Supplementary Design Statement.**Highland Folk Museum Store, Aultlarie Croft, Kingussie Road,****Newtonmore.****Introduction**

This supplementary design statement considers the rationale for a number of minor changes to the approved consent ref 2011/0418/DET dated 23rd May 2012, and forms part of an application for a 'Non-Material Variation' to that consent.

Fig. 3 Proposed lowered section with previously consented outline shown dotted.

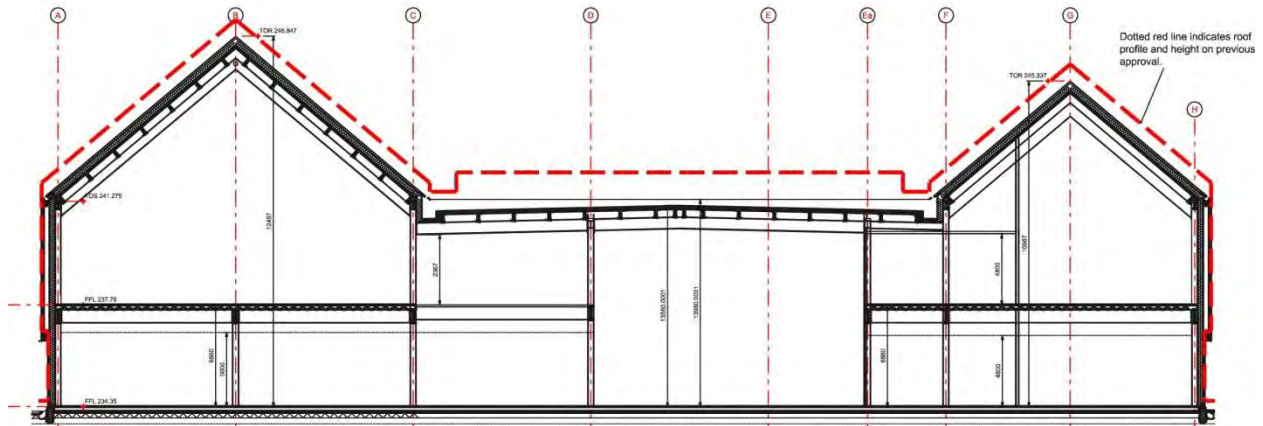
We have consulted with the manufacturers of the single ply roofing membrane products to determine the most effective way to ensure the prevention of water ingress. The previous profile and form is complex and in short the numerous changes in direction increase the risk associated with potential water ingress.

Following this advice, we have simplified the profile as indicated on the roof plan (drawings I/6787/06 & 11) to a shallow pitch roof with the ridge running parallel to the main pitched roofs. This roof is located lower than the parapet thus reducing the opportunity to view the membrane from anywhere other than from above.

We have revised the sections, and projected the viewing angles from the raised A86 and the slightly lower cycle path and this indicates that the single ply roofing cannot be seen when viewed end on. It is just possible to see the single ply roofing material from the junction of the site entrance since the road level rises at this point, but this is an oblique view and the flat roof is difficult to view since it will be obscured by the pitched roof of the office/administration wing of the building that projects forward. In addition, the density of the mature silver birch trees even without leaves will dissipate the remaining view to the extent that the single ply roofing material would be almost impossible to see. The photomontage above illustrates this point effectively.

- Remove Sedum from the central roof.
- Remove small pitched bays from the central roof.

- Introduce Sarnafil single ply membrane, colour; light grey, on simpler shallow fall roof, per drawings I/6787 - 06 rev 1, 08 rev 2 and 09 rev 3.
